ADDENDUM No. 02: November 27, 2024

Project: Jefferson Parish Economic Development Commission (JEDCO)
New Orleans Food & Beverage Incubator
700 Churchill Parkway
Avondale, LA 70094
Churchill Parkway in Avondale, LA (26-A1-A)

JEDCO RFQ #: 24-1211

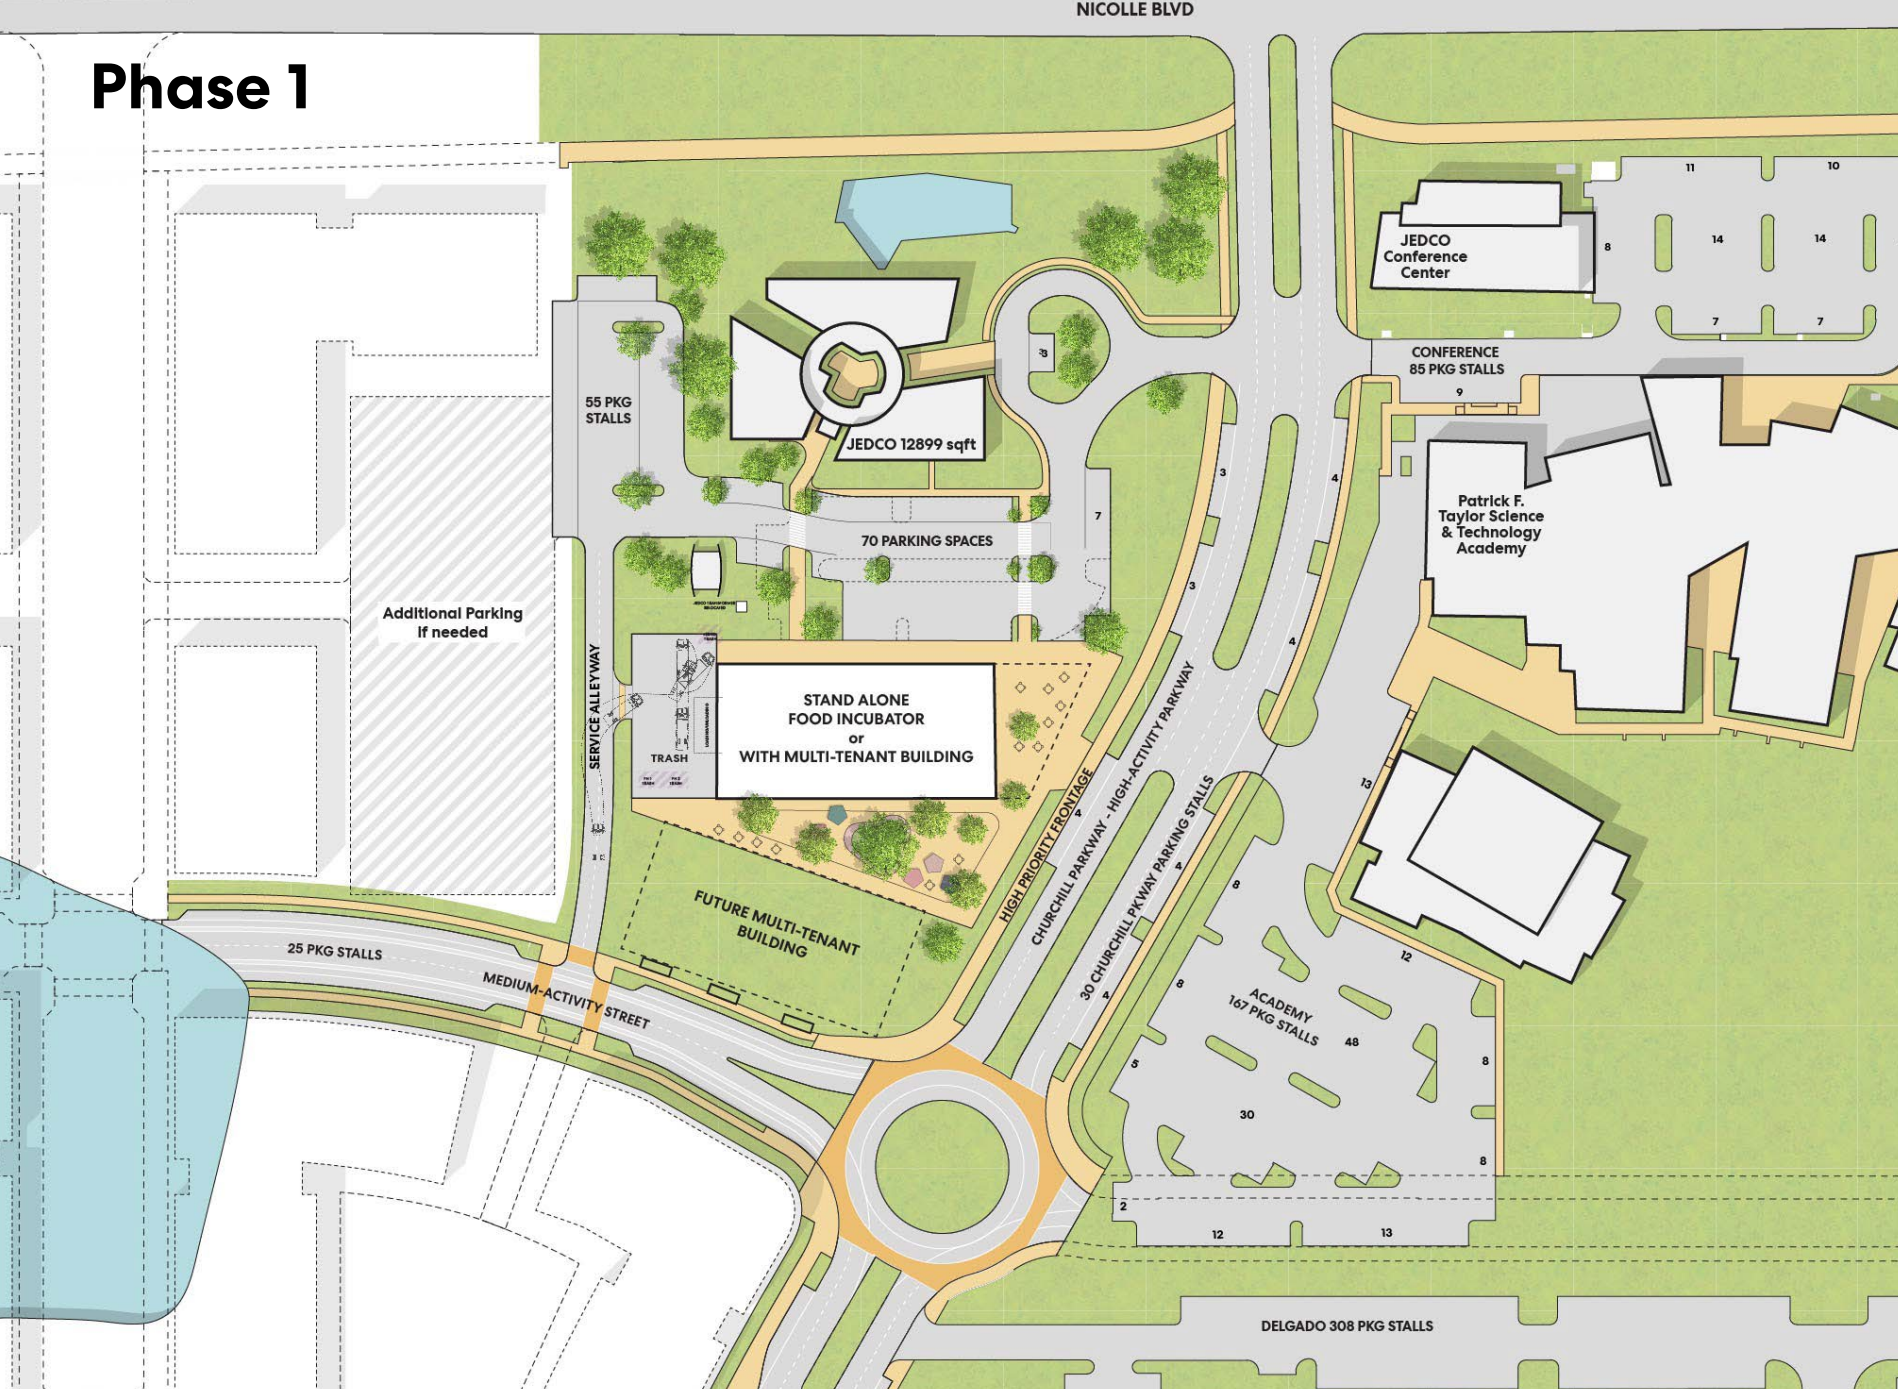
7. Are you able to provide a site plan or have the project area identified?

17. Can a more definitive location be provided.

ANSWER: Yes, see attached.

ANSWER: Yes, see attached site map.

RESUBDIVISION OF LOT 26-A1-C1 INTO LOTS 26-A1-C2 & 26-A1-C3 CHURCHILL FARMS SUBDIVISION JEFFERSON PARISH LOUISIANA

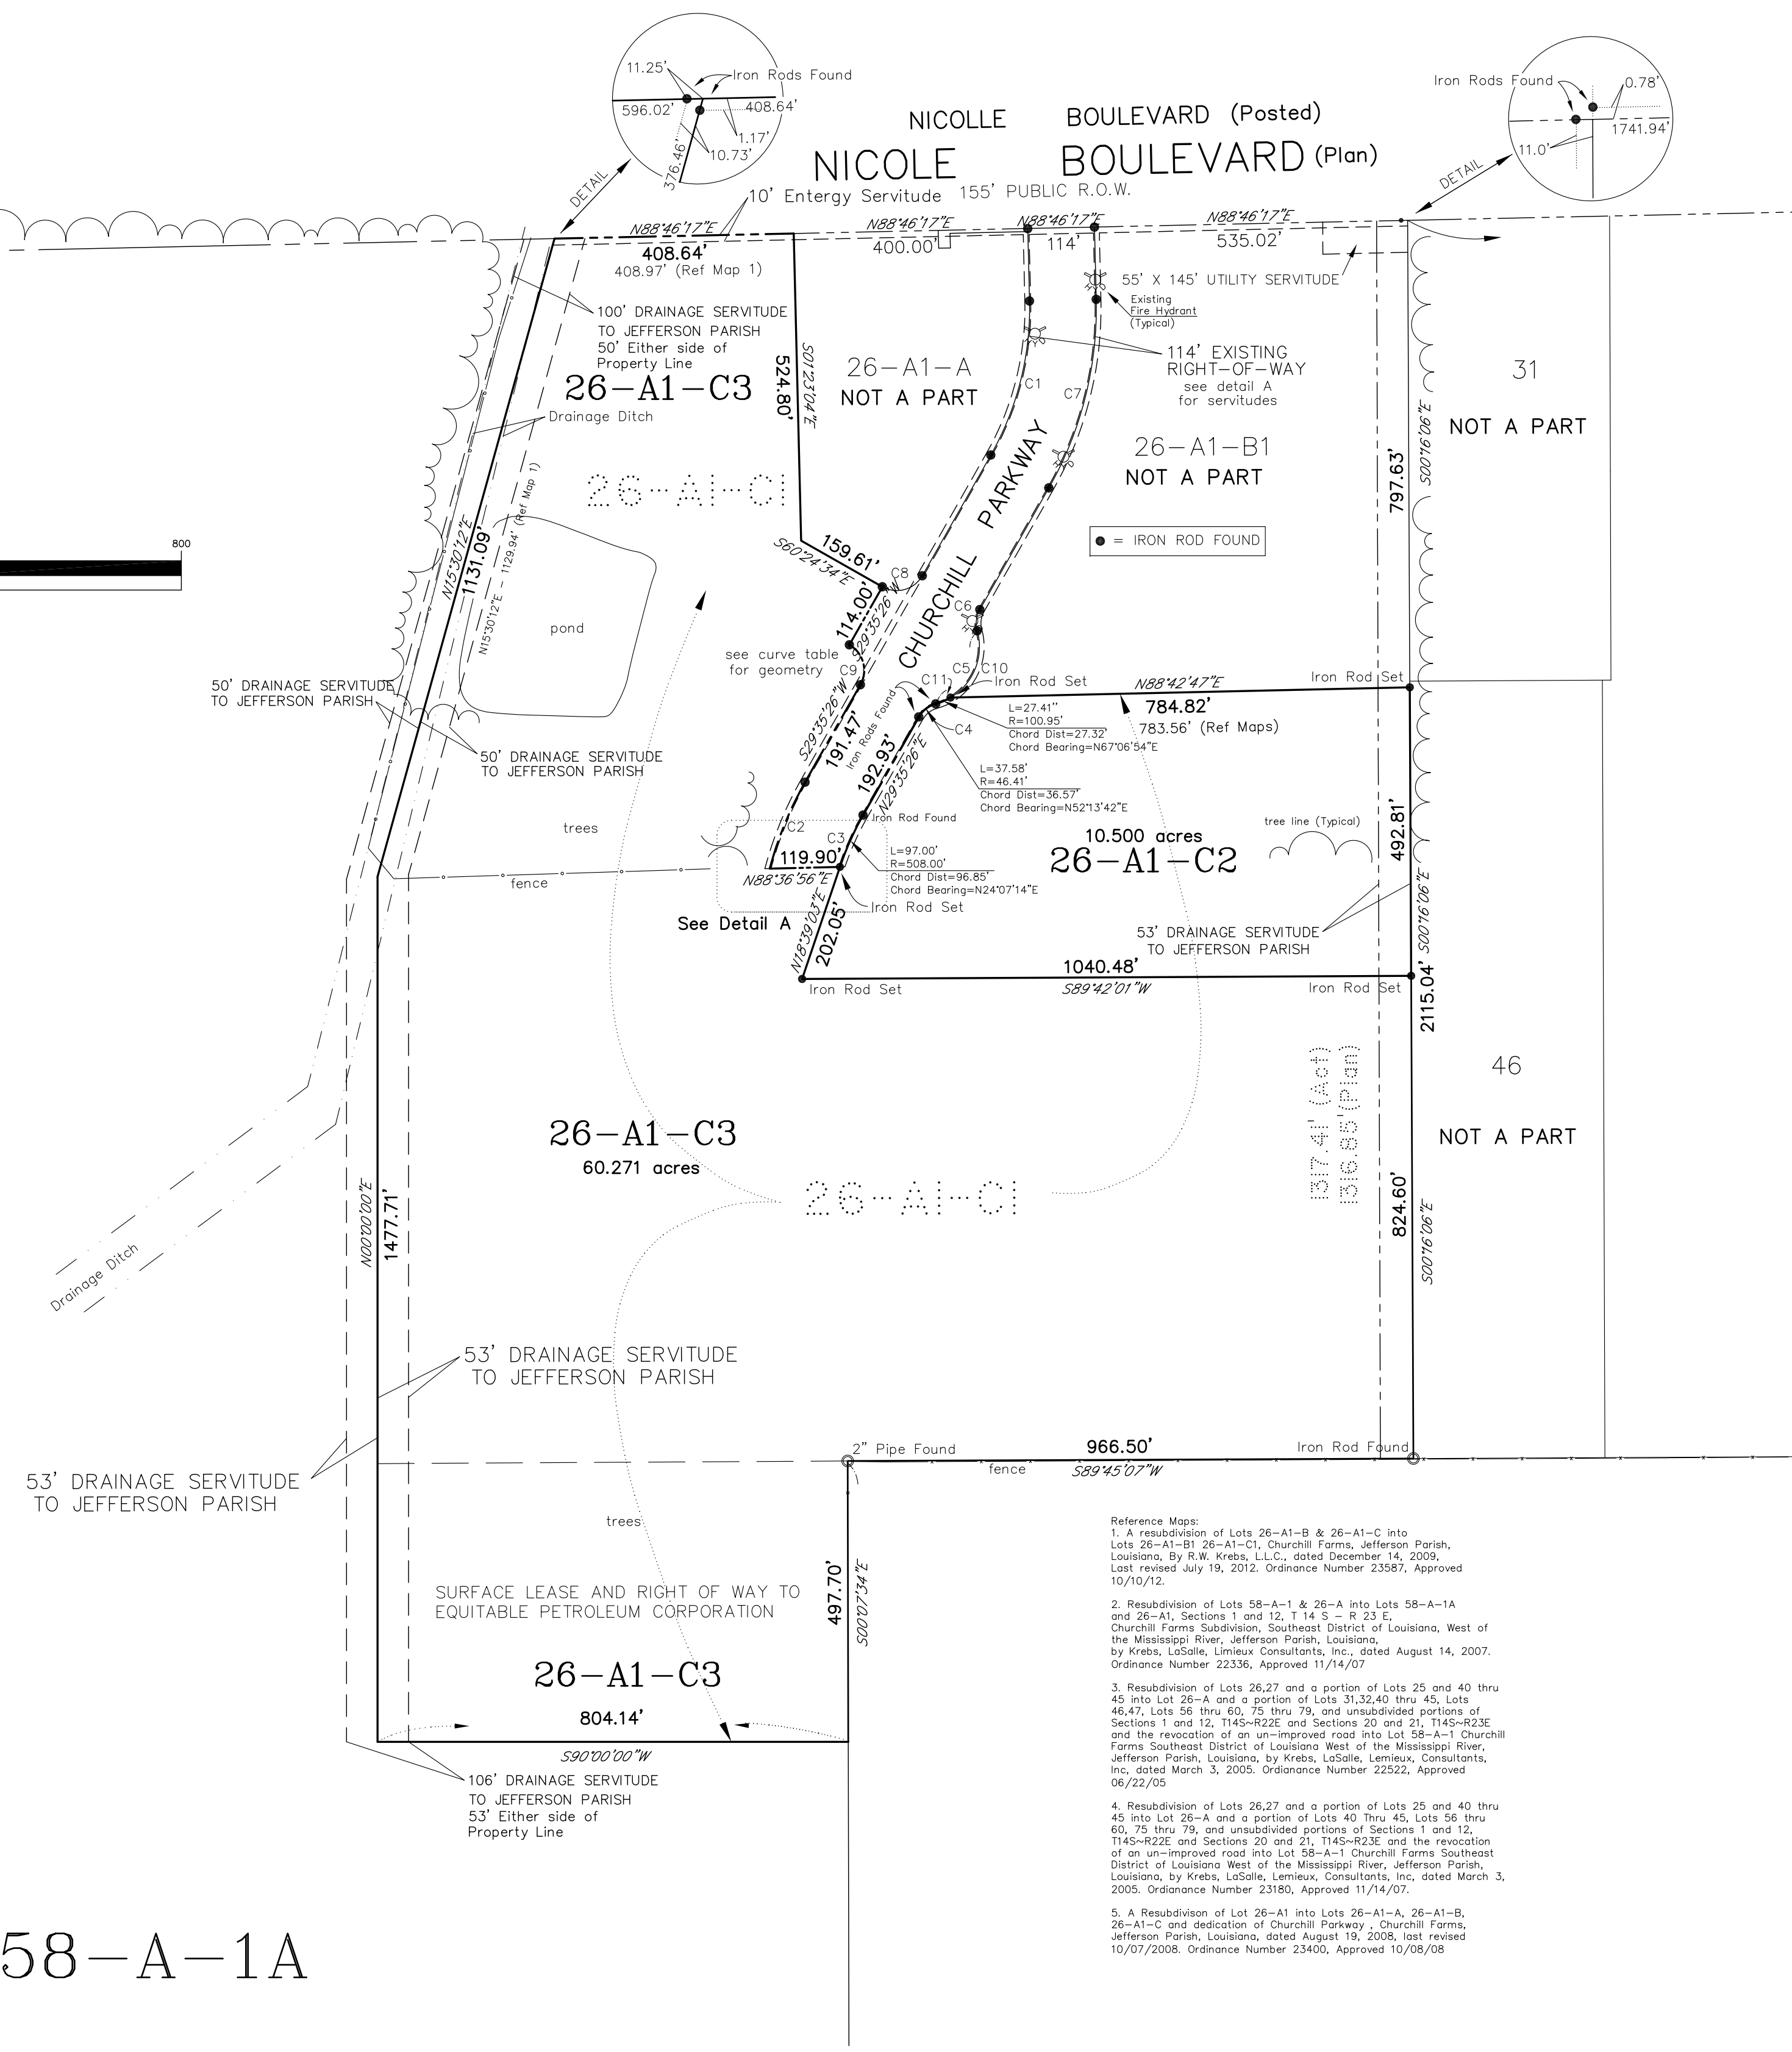
18. Is there a survey of the property that can be shared.

ANSWER: Yes, see attached. Please note that the subject property shares the same parcel as the

JEDCO administrative complex.
